TITLE OF PROJECT
FRANKLIN STREET EXTENSION

LOCATION OF PROJECT
MILEPOST 16.81

TITLE OF DRAWING
PLANS

TANY 92-21B

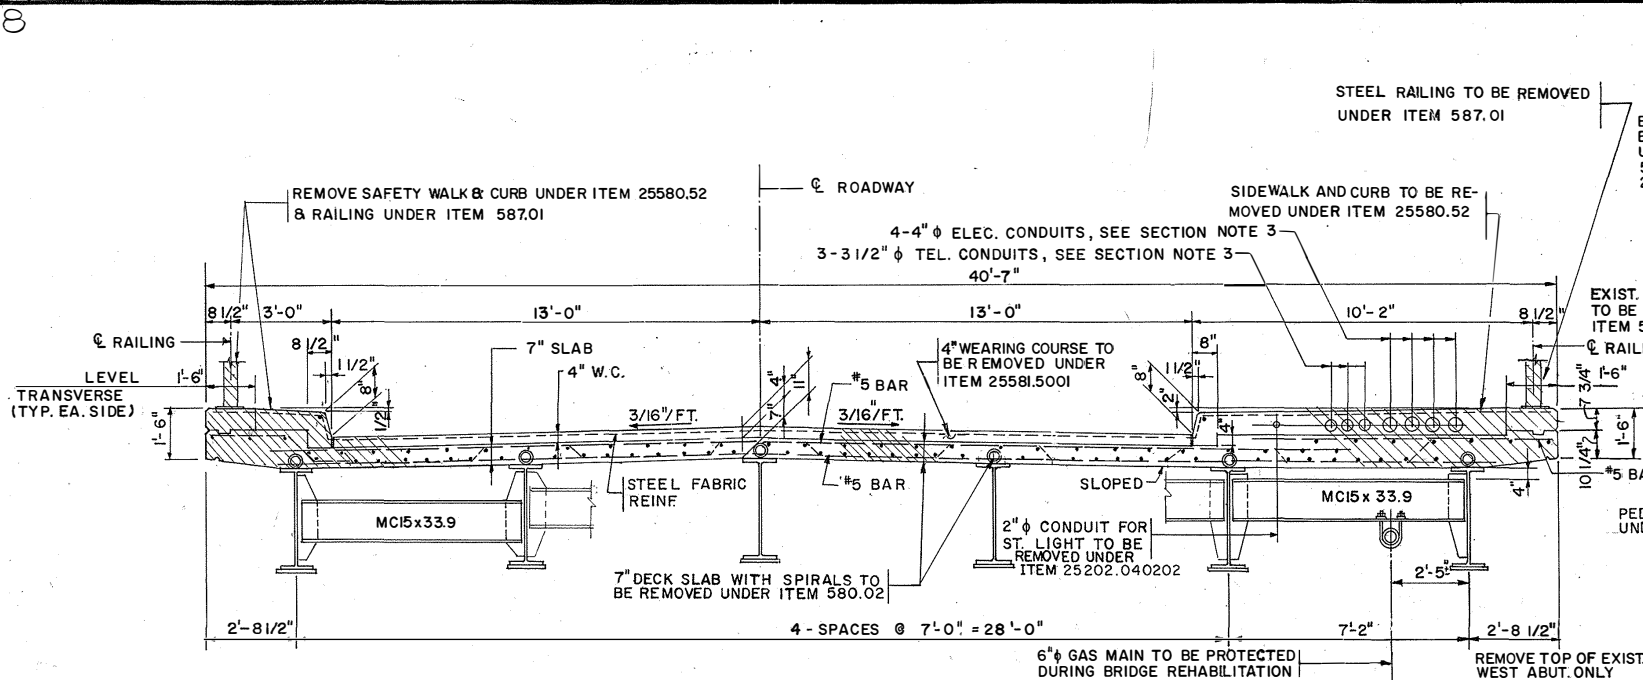
PROPOSED PLAN	
SCALE 1/16"=1'-0"	
AS - BUILT REVISIONS	
1	ABANDONED EXISTING PIPE AND BASIN, SEE OOC #03
2	NEW DRAINAGE BASIN. SEE OOC #3
3	REPLACED WITH 8" CONC. SIDEWALK A.O.B.E.
4	SHORTEN WEST APPROACH SLAB. SEE FINAL SUPPLEMENTAL, EXTEND BIT. PAVEMENT.

LAMP POST ANCHOR DETAIL

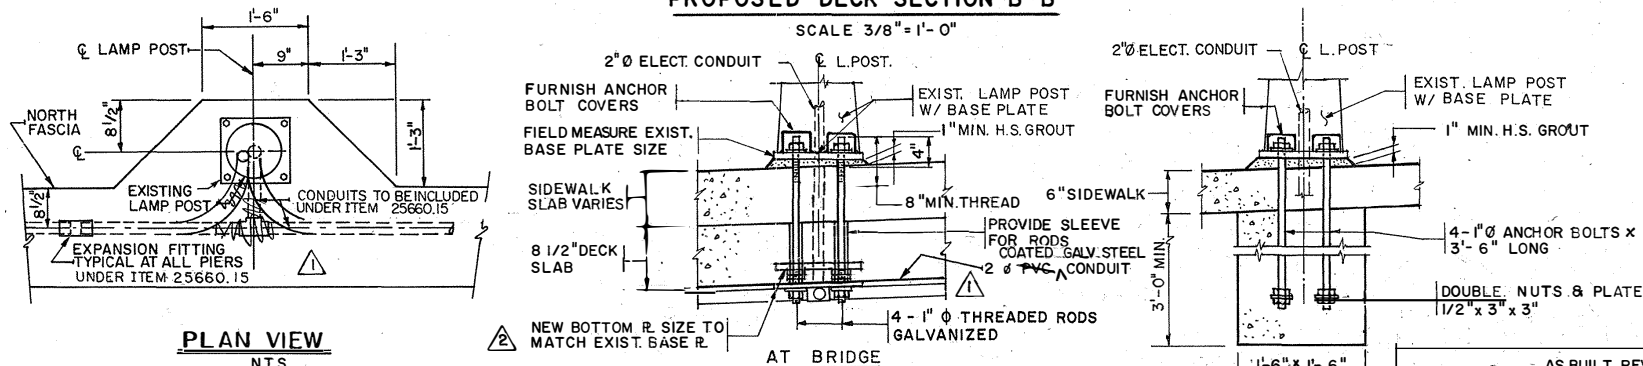
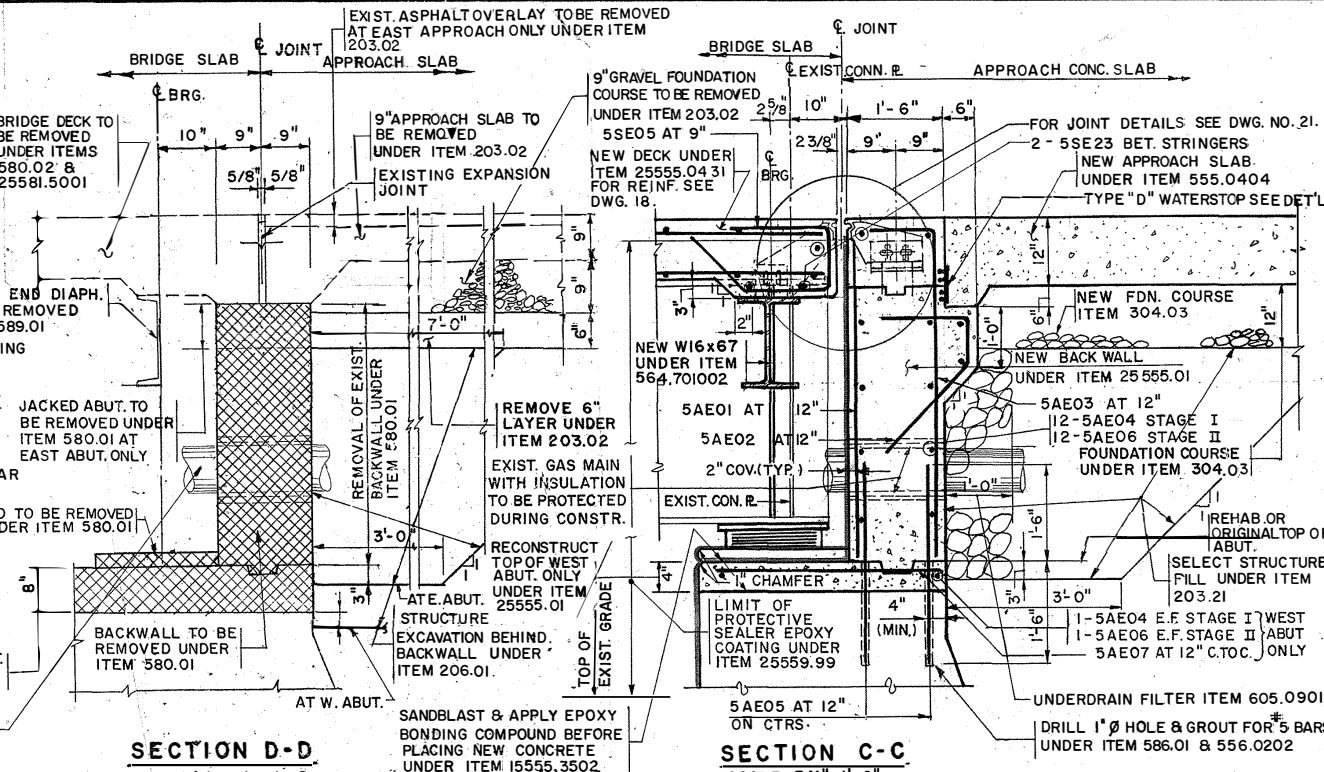
- | FIG. | REVISION |

| 1 | RELOCATED ELECTRICAL CONDUIT AS PER T.A. DESIGN AND AOB |
| 2 | SET THE LIGHT BASE ANCHOR BOLTS IN DECK PLACEMENT - AOB |

FRAMING PLAN

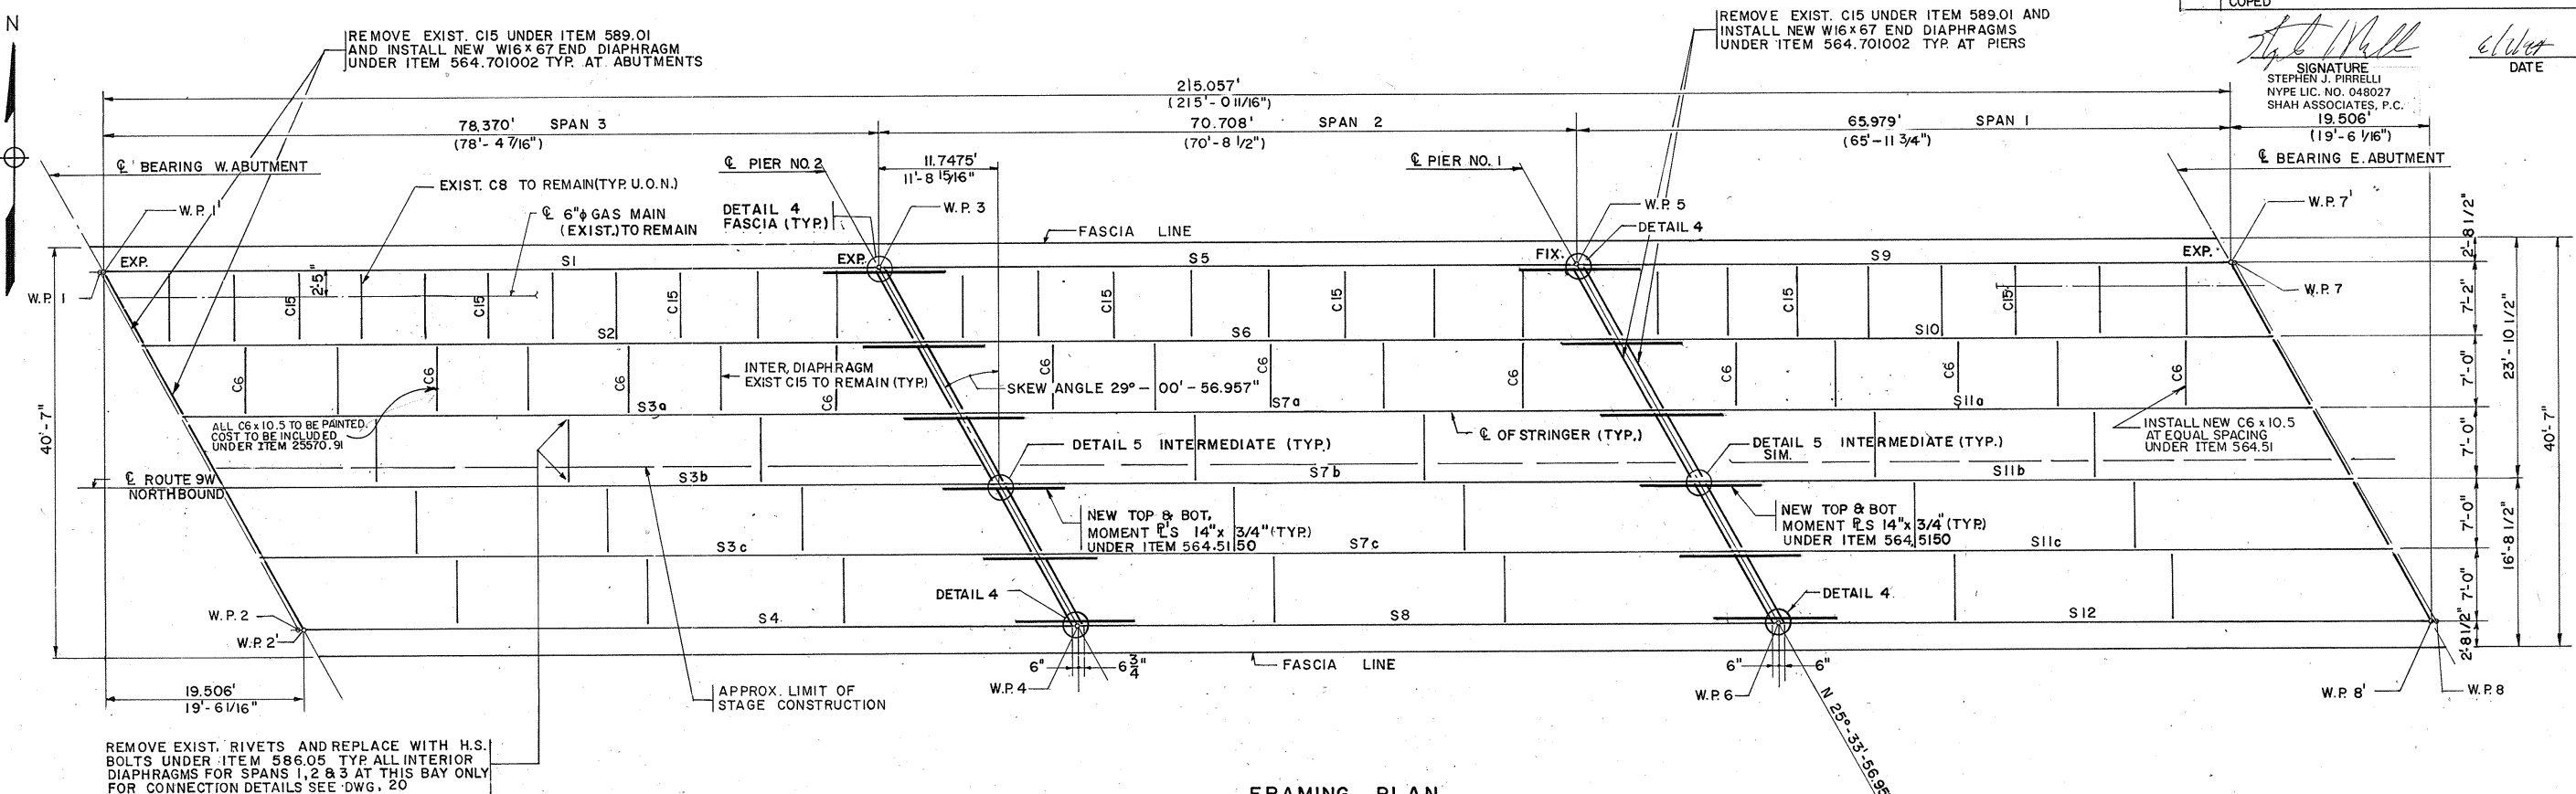
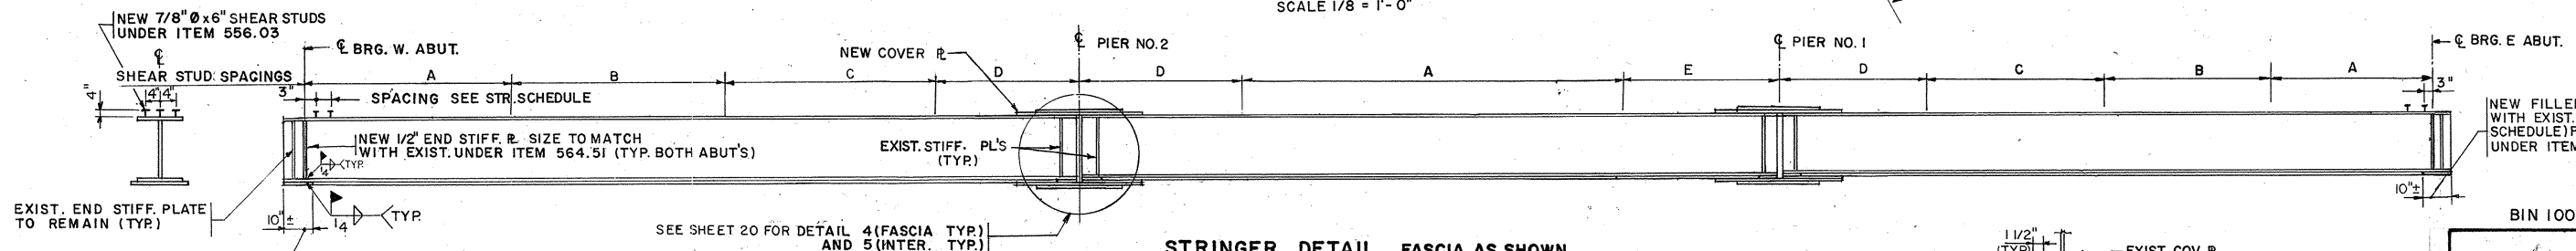
AS-BUILT REVISIONS	
1	SEE FINAL SUPPLEMENTAL
2	THE TOTAL SPAN LENGTH WAS CORRECTED (FFM)
3	6" SHEAR STUDS WERE USED
4	1 BOLT IS NOT INSTALLED IN THE FIRST ROW ON EITHER SIDE OF THE CENTER LINE IN THE TOP FLANGE DUE TO THE END OF THE STRINGER BEING CAPPED
